**DOCUMENT 00 90 00**  
**ADDENDUM**

**ADDENDUM No.:** 1

**RE:** WESTERN TECHNICAL COLLEGE  
COLEMAN CENTER 2024 RENOVATION  
368 6TH ST NORTH  
LA CROSSE, WISCONSIN 54601  
PROJECT NO. 23072

E101

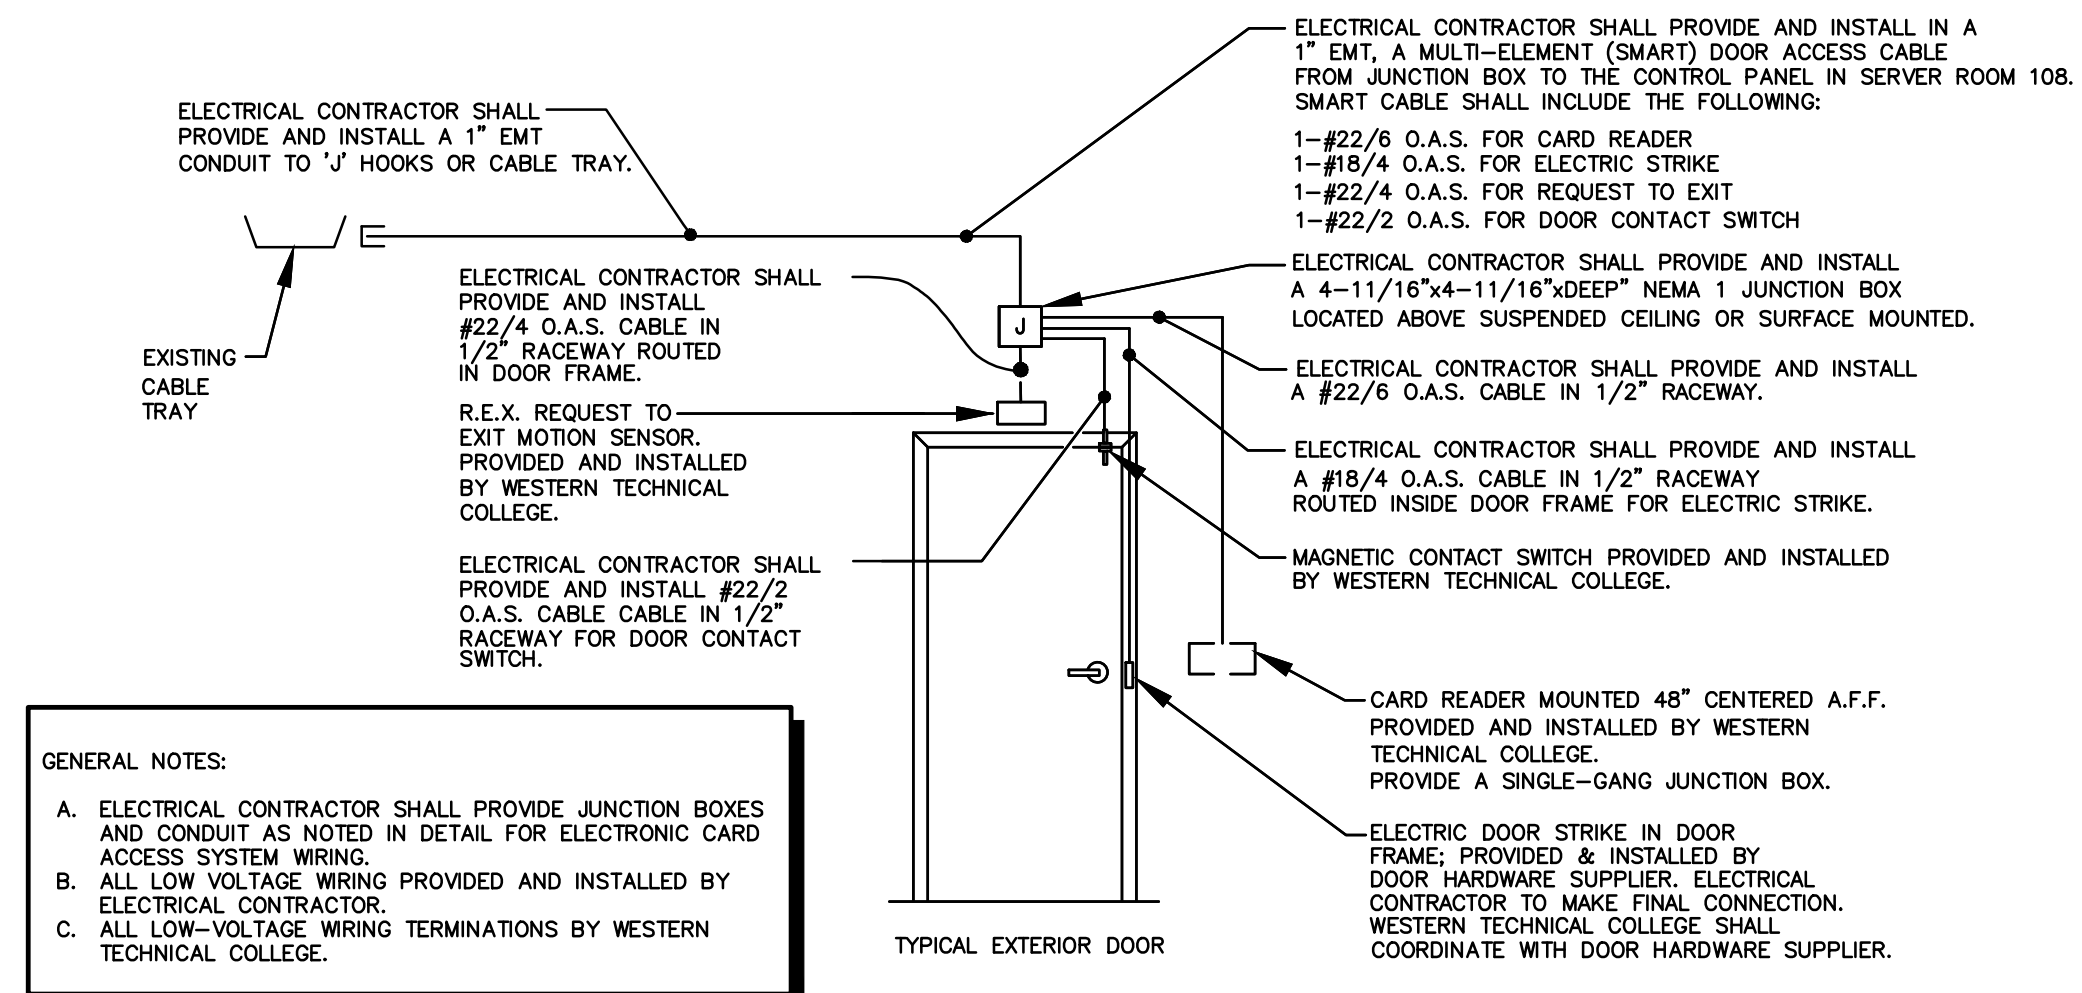
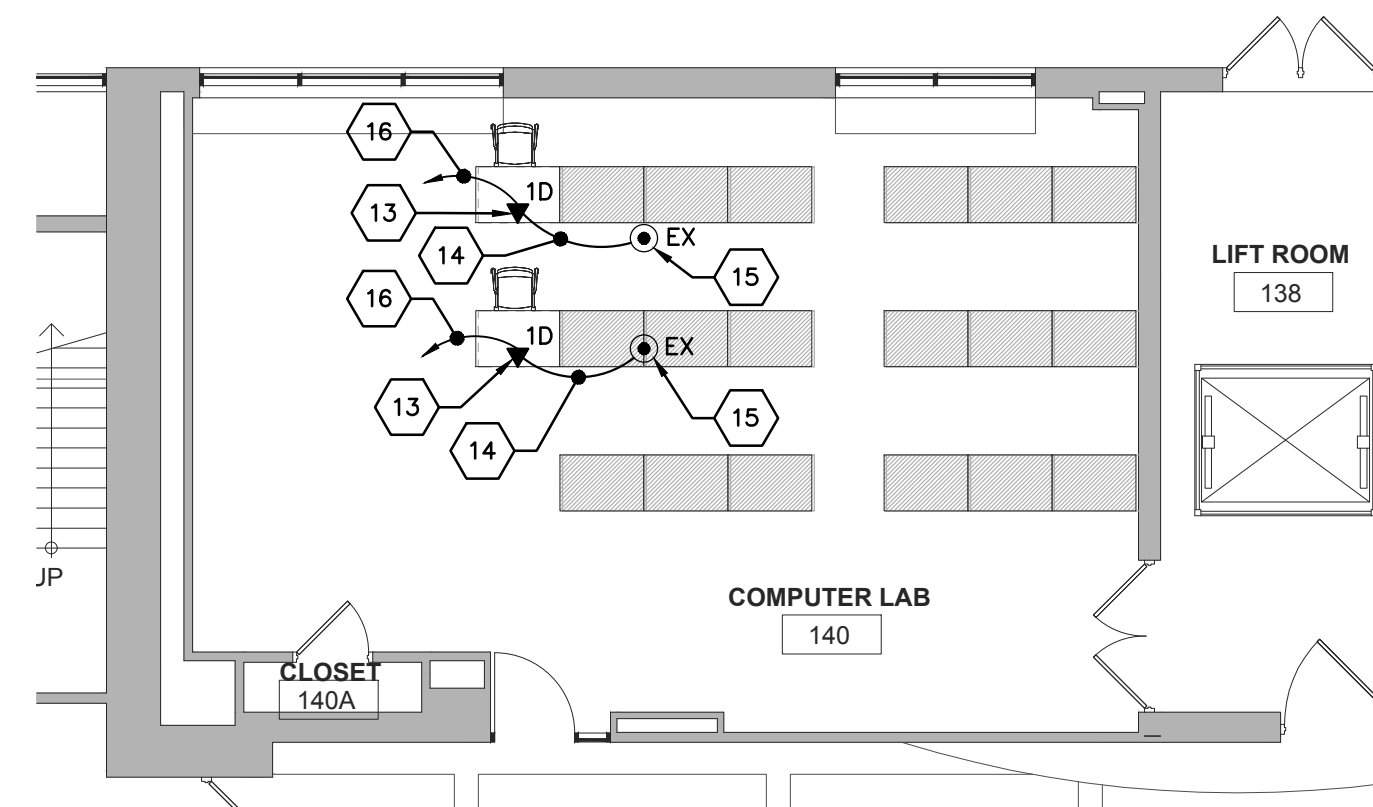
5. Sheet E101 CLASSROOMS ELECTRICAL PLANS 30"x42"
  - a. See the revised sheet included in this addendum. Disregard the previous version.
  - b. 4/E101: See clouded change for (1) added data jack for wall-mounted information monitor. See clouded change for (1) added duplex receptacle for wall-mounted monitor.

- c. Added Electrical Remodel Plan Notes Item #22.

- EXISTING 4-PORT DATA JACK TO REMAIN AS IS.
  - PROVIDE ONE NEW 1-PORT DATA JACK AT THIS LOCATION FOR INFORMATION MONITOR. IT WILL BE REQUIRED TO 'FISH' CAT6 CABLE AND INSTALL CUT-IN JUNCTION BOX IN EXISTING WALL. LOCATE ADJACENT TO NEW DUPLEX RECEPTACLE. FIELD VERIFY SCOPE OF WORK PRIOR TO SUBMITTING BID.
